**Identification cards — Contactless
integrated circuit cards — Proximity
cards —**

**Part 2:
Radio frequency power and signal
interface**

**AMENDMENT 1: Limits of electromagnetic
disturbance levels parasitically generated by
the PICC**

Amendment 1 to ISO/IEC 14443-2:2010 was prepared by Joint Technical Committee ISO/IEC JTC 1, *Information technology*, Subcommittee SC 17, *Cards and personal identification*.

Figure 18 — Illustration of allowed EMD spikes

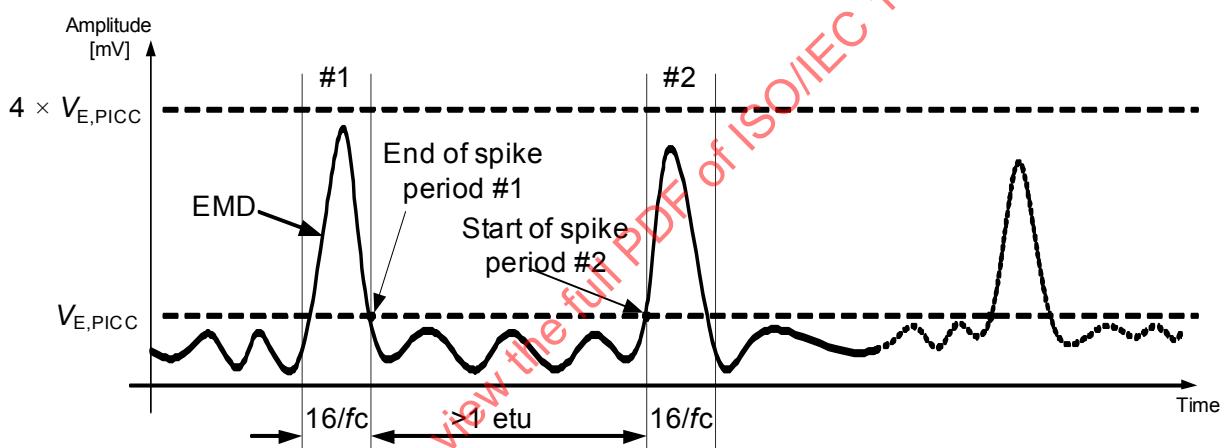
During this low EMD time, the EMD level may exceed $V_{E,PICC}$ for no more than two short periods of $16/f_c$ if:

- it never exceeds $4 \times V_{E,PICC}$ and
- in case of two periods, the time between the two periods is greater than 1 etu.

Figure 18 shows an illustration of such allowed EMD spikes.
